NOTICE OF OPEN MEETING
AGENDA
PLANNING AND ZONING COMMISSION
City of Moberly
City Council Chambers – Moberly City Hall
101 West Reed Street
April 24, 2023
6:00 PM

Subject: Zoning Application 110 W Carpenter St (Agenda Items 2)

CITY OF MOBERLY, MISSOURI
SITE PLAN REVIEW

Re: Submittal Letter for “110 W Carpenter St”

PRELIMINARY PLAT
PRELIMINARY / FINAL DEVELOPMENT PLAN

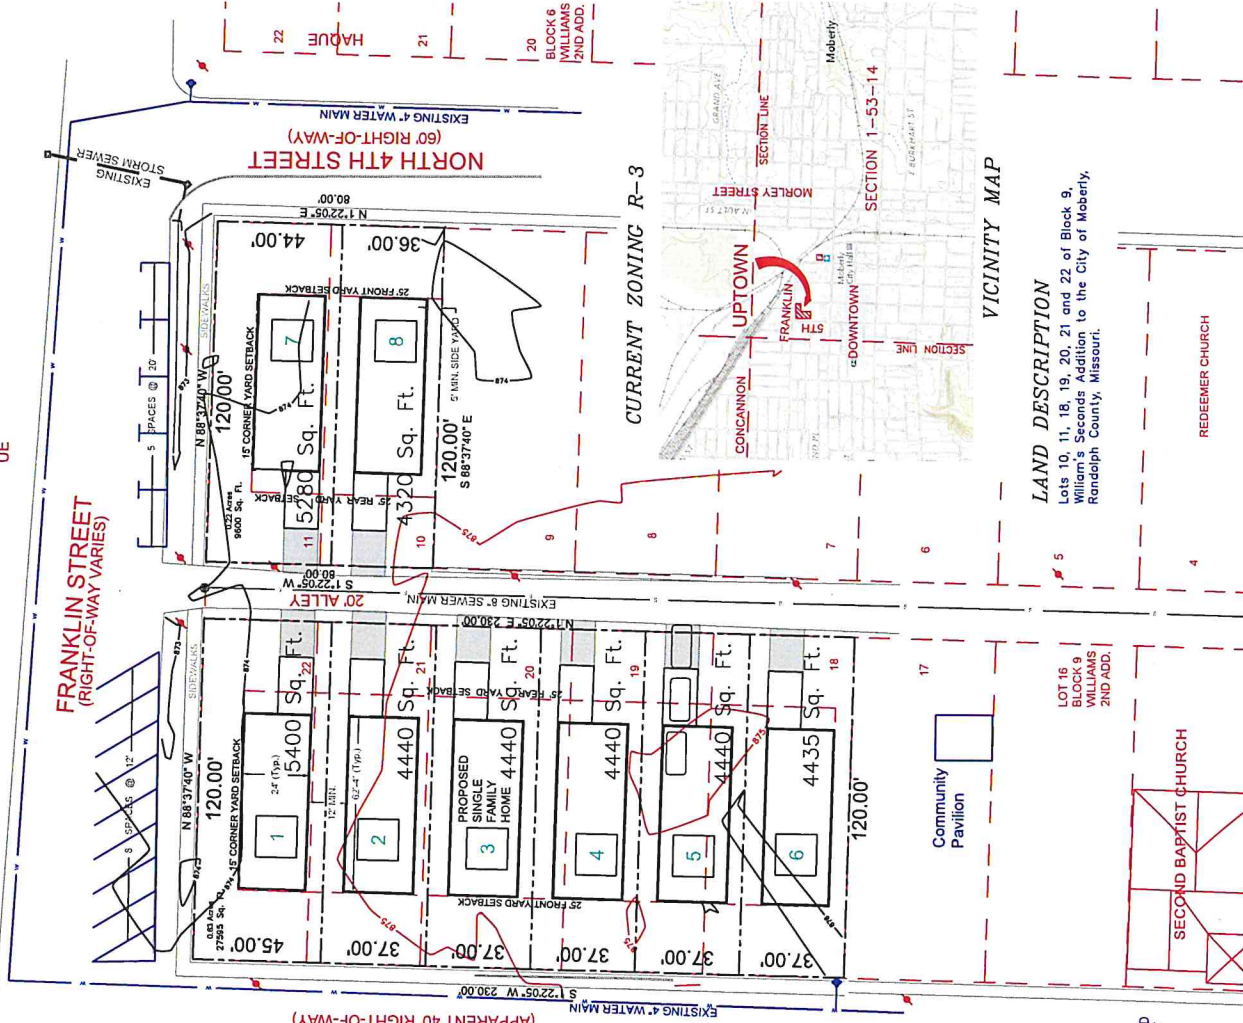
City Staff has reviewed the application and the code sections that apply. The existing proposed design for the re-plat and re-zoning of the lots is requesting to change the existing 5 lots on N 5th Street to become 7 lots on N 5th St. The 2 existing lots on N 4th Street will remain as 2 lots but shift property lines to accommodate the planned

After reviewing the proposed planned development requests, the developer is requesting a reduction in lot square footage from 6,000 sq ft to 4400 sq ft, a reduction in lot frontage from 60 ft to 37 ft, and an increase in lot coverage from 50% to 60%.

The development shows an increase in additional visitor parking in addition to the garages on the north side for additional (13 spaces) parking. Also, existing infrastructure in the form of streets, water, sewer, electrical, fire hydrants, and lighting are already in place for these lots. There are not intended to be any additional construction plans to submit for infrastructure development following this proposed platting / planned development.

City Staff recommends that if there are no additional changes or recommendations by the Planning and Zoning Commission, that they forward the Plat/Planned Development applications to City Council with consideration as a Final Plat as there is no infrastructure development to occur that would require dedication to City of Moberly.
